BusConnects Core Bus Corridors  
Ballymun/Finglas to City Centre  
Scheme

Stage 1 Road Safety Audit

**Document Ref:** P21-026-PSW1-RP-001

Example: Drawing No BCIDD-ROT-GEO\_GA-0304\_XX\_00-DR-CR-0002 (Rev S3 L02)

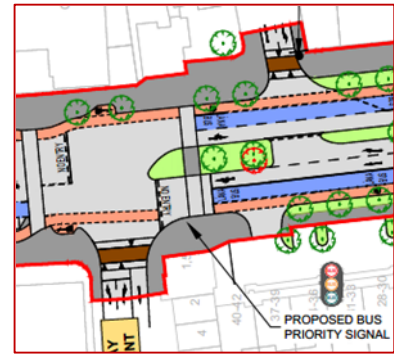
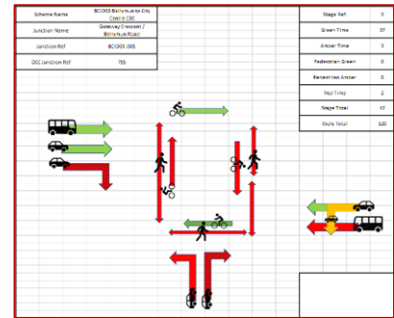
Summary: *Left turning manoeuvres are indicated during the same signal phase as straight-ahead cyclists where turning drivers may be insufficiently aware of cyclists proceeding straight at a number of the protected intersections/junctions within the Scheme.*

At a number of signalised protected junctions within the Scheme, left turning traffic is indicated as occurring during the same phase as straight-ahead cyclists, often on an amber signal.

Where the straight through cycle lane is offset from the adjacent traffic lane, for example where it is separated by a bus lane, there is a risk that drivers, when given a green or amber signal, may not be aware of, or prepared for, a straight-ahead cyclist also proceeding through the junction, resulting in possible vehicular/cyclist collisions.

The signal phasing should be such that straight-ahead cyclists do not proceed at the same time as left-turning traffic where the left-turning traffic is separated from the cycle lane by a bus lane.

Example: Drawing No BCIDD-ROT-GEO\_GA-0304\_XX\_00-DR-CR-0002 (Rev S3 L02)

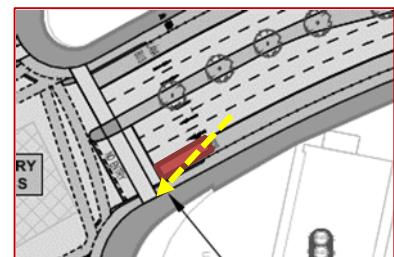
Summary: *High-sided vehicles in the bus lane may block visibility to the signal heads for drivers in the adjacent general traffic lanes.*

The proposed number of lanes and the provision of a nearside bus lane along the CBC routes is such that drivers approaching signalised junctions/crossings may fail to have adequate visibility to the primary signal heads due to the lateral distance to the footpath, where the signal heads are most likely to be located, and the possibility that their view of the signals may be obscured by a high-sided vehicle or bus in the adjacent lane.

In some cases, the proposed location of bus stop is immediately upstream of a signalised junction (e.g. on the northbound carriageway at Chainage A2230), and may result in a stationary bus at the bus stop blocking an approaching northbound driver's visibility towards the signals.

This could result in a driver being insufficiently aware of the signal status and a failure to stop, leading to overshoot into the pedestrian crossings or junctions, resulting in vehicular/pedestrian collisions or side-on collisions.

During the design development the need for high-mast or cantilever signal supports should be assessed, and these signal supports provided where required, so that drivers have adequate forward visibility to the signals on their approach to a junction/crossing.

The location of bus stops should not result in an approaching driver’s view of the signals being blocked by stationary buses at the bus stop.

*Example: Drawing No BCIDD-ROT-GEO\_GA-0304\_XX\_00-DR-CR-0008 (Rev S3 L02)*

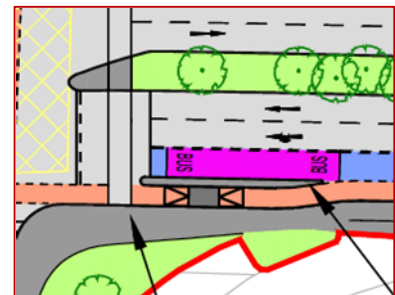
*Summary: Insufficient bus-stop island width could increase the risk of pedestrians, waiting for a bus, encroaching into the cycle track resulting in possible pedestrian/cyclist collisions.*

The width of the floating islands at various bus stops throughout the scheme appears to be relatively narrow.

Should pedestrians waiting for a bus choose to wait within the island, there is a risk that they could encroach into the adjacent cycle track, impede cyclists and increase the likelihood/possibility of pedestrian/cyclist collisions.

In addition, it is unclear if the width of the proposed islands is sufficient to allow a wheelchair user to access public transport safely, in particular, where there are other passengers embarking/disembarking at the same time.

Ensure the floating islands at bus stops along the route can safely accommodate the expected volumes of waiting passengers, and that they are of sufficient width to accommodate all public transport users safely.

3.1.2	Yes	Yes		
3.1.3	Yes	No	<p>The bus shelter will be located on the footpath rather than the island to encourage pedestrians to wait here. The floating island function here is to allow pedestrians a chance to board without risk of a cyclist following behind or the bus ramp to be laid without creating a hazard to cyclists. It is not intended to accommodate waiting patrons since there is insufficient space to provide such an island.</p> <p>The islands will be of sufficient width to accommodate the expected volumes of passengers safely.</p>	Yes

*Example: Drawing No BCIDD-ROT-GEO\_GA-0304\_XX\_00-DR-CR-0001 (Rev S3 L02)*

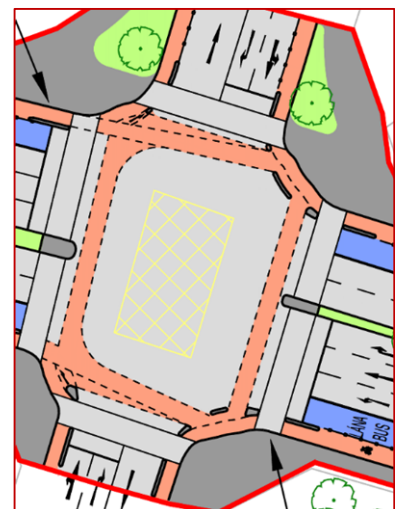
*Summary: Small islands proposed at signalised junctions may be impractical to sign, and lead to these islands being struck.*

Small islands have been indicated within signalised junctions to separate vehicle, cyclist, and pedestrian movements.

The relatively small size of the islands, and their number within a junction, may be impractical to sign, and lead to these signs being struck by vehicles and cyclists, leading to material damage and loss of control collisions.

Ensure physical islands can accommodate traffic signs and provide at least 450mm between the kerb and sign edge.

*Example: Drawing No BCIDD-ROT-GEO\_GA-0304\_XX\_00-DR-CR-0002 (Rev S3 L02)*

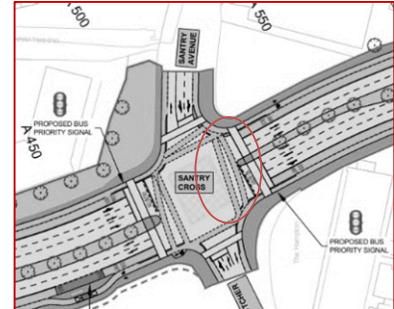
*Summary: Multiple cycle lanes indicated may result in cyclists misinterpreting the layout to be two-way cycle lanes resulting in conflicts.*

It is unclear what the purpose/need is for the duplicate cycle lanes across the arms at a number of the signalised junctions (e.g. Santry Cross junction, Collins Avenue junction).

The proposed layouts could result in confusion for cyclists, who may misinterpret the layout as consisting of bi-directional cycle lanes, leading to erratic or inappropriate/unsafe manoeuvres resulting in collisions with other cyclists using the junction.

The layout of the proposed cycle lanes at the signalised junctions should be clear and easily understood by cyclists.

*Examples: Albert College Court, Shangan Road, Hampstead Avenue & Library access.*

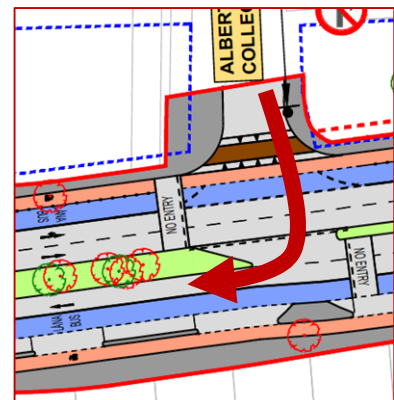
*Summary: Central median layout at a number of side roads is wide and may allow for unsafe manoeuvres to be undertaken.*

The proposed, and the existing, road layout at number of side roads is for left-turns-only exiting the side road while permitting uncontrolled right-turns into the side road.

The road layout at these locations includes a relatively wide break in the median such that vehicles can and, as observed during the Site Visit, do turn right from these side roads onto the Ballymun Road.

Vehicles turning right from the side roads at these locations are at greater risk of collisions with through-traffic on the multi-lane carriageway and also present a risk to right-turning drivers wishing to turn into the side road who may not anticipate a vehicle turning right from the side road.

The road layout should be amended to prevent right-turns from these side road, possibly by the provision of a central splitter island within the side road at its junction with Ballymun Road which is profiled to encourage left-turns only out of the side road. Alterations to the arrangement of the right-turn lane and associated gap in the median may also assist in discouraging inappropriate right-turns out of the side road at these locations.

*Location: Drawing No BCIDD-ROT-GEO\_GA-0304\_XX\_00-DR-CR-0001 (Rev S3 L02)*

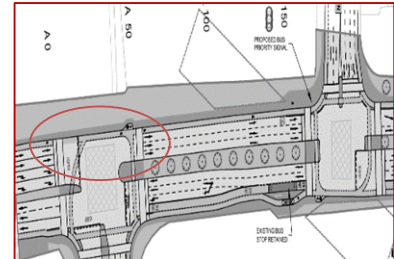
*Summary: Two lane approach at the junction with three lanes downstream might lead to conflicts due to late lane change manoeuvres.*

There is a concern that drivers unfamiliar with the road layout who wish to proceed south may find themselves inadvertently in the left-turn only lane, leading to late lane-change manoeuvres and possible side-swipe collisions.

*Location: Drawing No BCIDD-ROT-GEO\_GA-0304\_XX\_00-DR-CR-0002 (Rev S3 L02)*

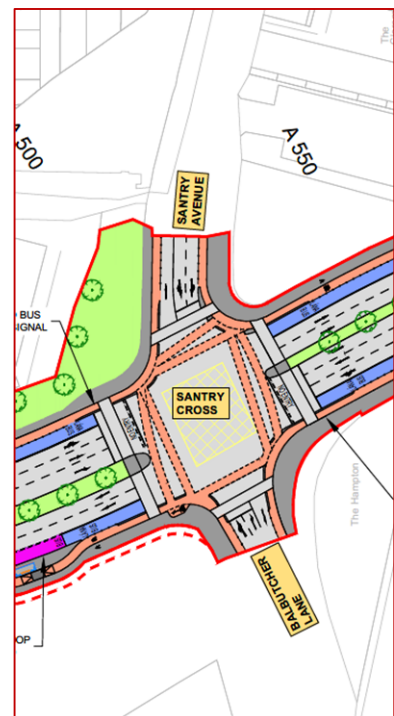
*Summary: Proposed road layout does not appear to tie-in with the existing road layout at the scheme extents.*

It is unclear if the extent of the proposed works on Santry Avenue or Balbutcher Lane will be sufficient to tie-in the revised road layout on these side roads on their immediate approach to the Santry Cross Junction with the existing road layout to the east/west respectively.

3.2.4	Yes	No	Planning is being sought for side road junctions to tie into future anticipated cycle facilities. At the locations where this will occur, a label "Future cycle facility" will be added. In the event these planned cycle facilities have not progressed by detailed design stage, the side road will tie into existing appropriately.	Yes

*Location: Drawing No BCIDD-ROT-GEO\_GA-0304\_XX\_00-DR-CR-0002 (Rev S3 L02) (Stage 5 of the signal phasing)*

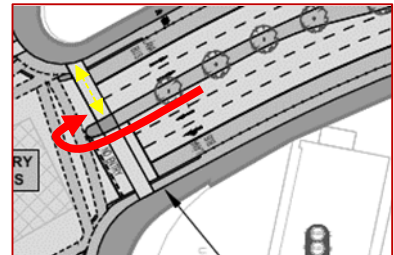
Southbound vehicles approaching the Santry Avenue junction are provided with a green signal in Stage 5, which permits right-turn manoeuvres, at the same time as pedestrians are permitted to cross the northbound carriageway, on the northern side of the junction.

Should a southbound vehicle undertake a u-turn at the junction this could result in vehicular/pedestrian collisions.

Separate phases for the right turning traffic and the pedestrian crossing should be provided, or if u-turns are not permitted at this location then the appropriate regulatory signage should be provided.

*Location: Drawing No BCIDD-ROT-GEO\_GA-0304\_XX\_00-DR-CR-0002 (Rev S3 L02)*

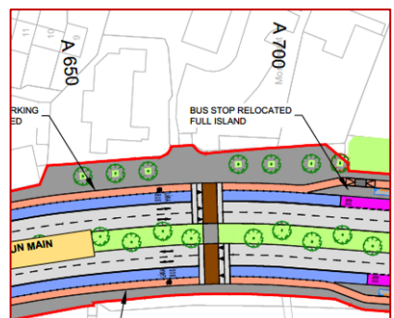
A number of properties on the eastern side of the Ballymun Main Street, Chainage A650 to A700, currently have vehicular access directly from the Main Street. It would appear that it is proposed to provide bollards along the interface between the cycle lane and the bus lane continuously along this section, which would impede vehicular access/egress from these properties.

In addition, new planting has been indicated to the north of the entrance to the Nursing Home at this location. It is unclear what species of vegetation is proposed at this location, however, there is a risk that the planting may impede visibility for drivers of exiting vehicles towards approaching cyclists/traffic resulting in unsafe exiting manoeuvres and possible side-on collisions.

The proposed road layout should permit safe access/egress to these properties. In addition, during the design development, ensure the proposed tree species will not result in reduced visibility for drivers exiting the Nursing Home.

*Location: Drawing No BCIDD-ROT-GEO\_GA-0304\_XX\_00-DR-CR-0004 (Rev S3 L02)*

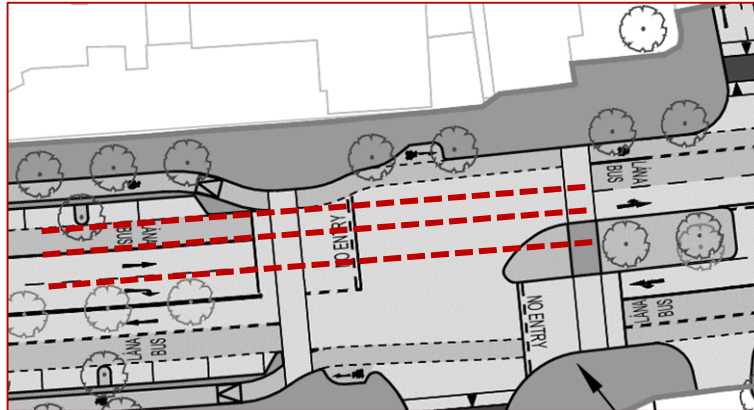
*Summary: Southbound lane alignment through the Gateway Crescent junction may result in side-swipe collisions.*

The traffic lanes upstream and downstream of the junction should better align, or guidance road markings should be provided to better direct drivers into the correct lane downstream of the junction.

*Location: Drawing No BCIDD-ROT-GEO\_GA-0304\_XX\_00-DR-CR-0004 (Rev S3 L02)*

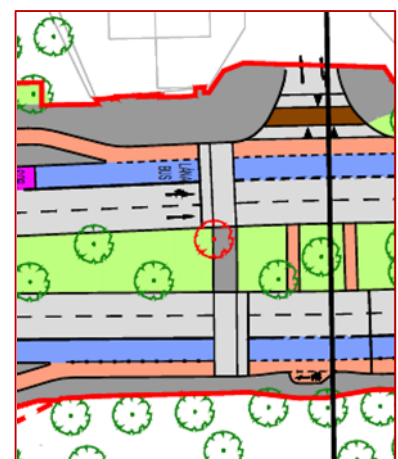
It is proposed to provide a right turning pocket for cyclist on Ballymun Road to access Shanliss Road. It is also proposed to provide cycle facilities in the central median. It is unclear how the facilities provided would operate and if cyclists would be able to safely cross the dual carriageway at this location, particularly during peak traffic times.

*Location: Drawing No BCIDD-ROT-GEO\_GA-0304\_XX\_00-DR-CR-0005 (Rev S3 L02)*

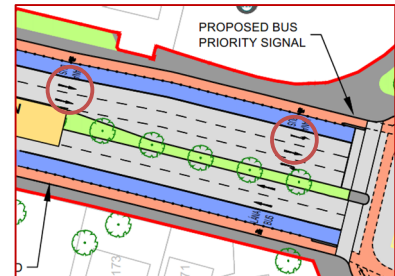
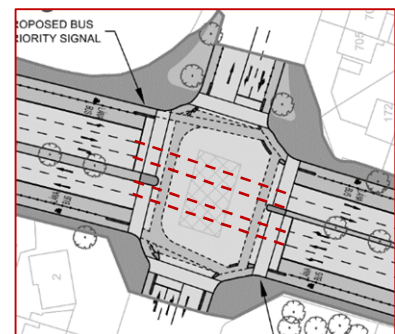
*Summary: Nearside lane becomes a left-turn only lane. This might result in side swipe collisions should drivers attempt to change lanes if they wish to travel straight-ahead.*

The nearside lane on the northbound & southbound approach to the Collins Avenue junction becomes a left-turn only lane, which may not be anticipated by drivers resulting in late lane-change manoeuvres and possible side-swipe collisions.

In addition, two lanes have been indicated downstream of the junction which may encourage some drivers to travel within the nearside lane and then proceed straight-head at the junction, a manoeuvre which may not be anticipated by drivers in the straight-ahead lane leading to possible side-swipe collisions through, or on the exit, from the junction.

The nearside general traffic lane should cater for both straight-ahead & left-turn traffic at the junction.

Alternatively, adequate advance notice by means of signage & lane-specific destination text road markings should be provided so that drivers can enter the appropriate lane for their intended destination upstream of the intersection, and the number of general traffic lanes downstream of the junction should match the number of general traffic lanes entering the junction.

*Location: Drawing No BCIDD-ROT-GEO\_GA-0304\_XX\_00-DR-CR-0009 (Rev S3 L02)*

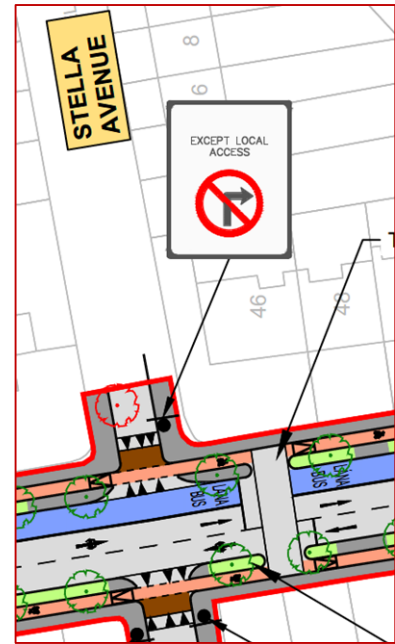
*Summary: Proximity of signalised crossing to side road junction, and the position of planting on the approaches to the crossing, could result in drivers failing to stop resulting in overshoot and possible vehicle/pedestrian collisions.*

*Location: Drawing No BCIDD-ROT-GEO\_GA-0304\_XX\_00-DR-CR-00011 (Rev S3 L02)*

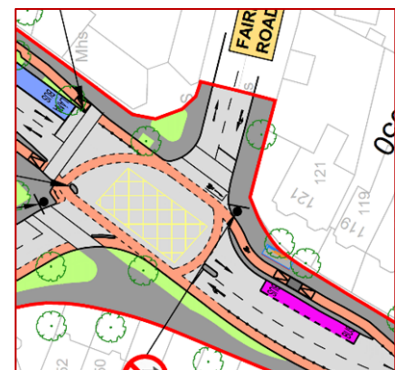
*Summary: No pedestrian crossing indicated on the southern side of the Botanic Road/St Mobhi Road junction along a likely pedestrian crossing desire line.*

*Location:* Drawing No BCIDD-ROT-GEO\_GA-0304\_XX\_00-DR-CR-00016 (Rev S3 L02)

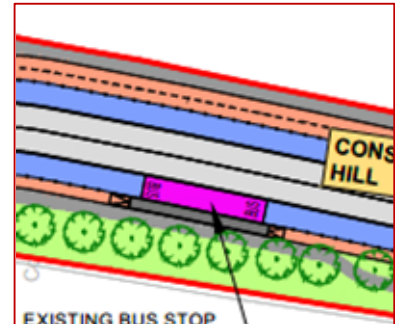
*Summary:* Cyclist proximity to a stationary bus at the bus stop could result in collisions between cyclists and disembarking passengers.

The route for northbound cyclists at the bus stop at Chainage A6040 is such that cyclists may be passing close to a stationary bus where visibility to them may be restricted, presenting a risk to disembarking passengers and possibly resulting in collisions between cyclists and disembarking passengers.

The layout at this location should be amended so that cyclists can safely pass the bus stop away from a stationary bus and waiting passengers.

*Location: Drawing No BCIDD-ROT-GEO\_GA-0304\_XX\_00-DR-CR-00027 (Rev S3 L02)*

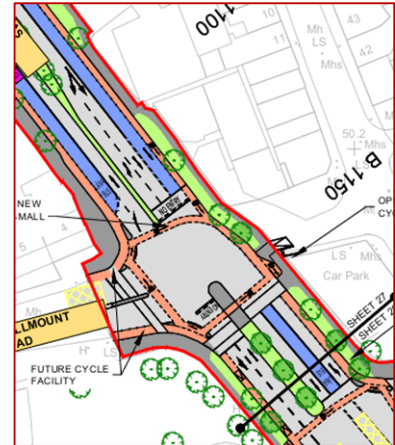
*Summary: Requirement for left-turning traffic to cross straight-ahead bus lane traffic may lead to side-swipe collisions.*

On the southbound approach to the Wellmount Road junction, the signal phasing indicates that general traffic in the straight-ahead lane and traffic in the adjacent bus lane can proceed at the same time.
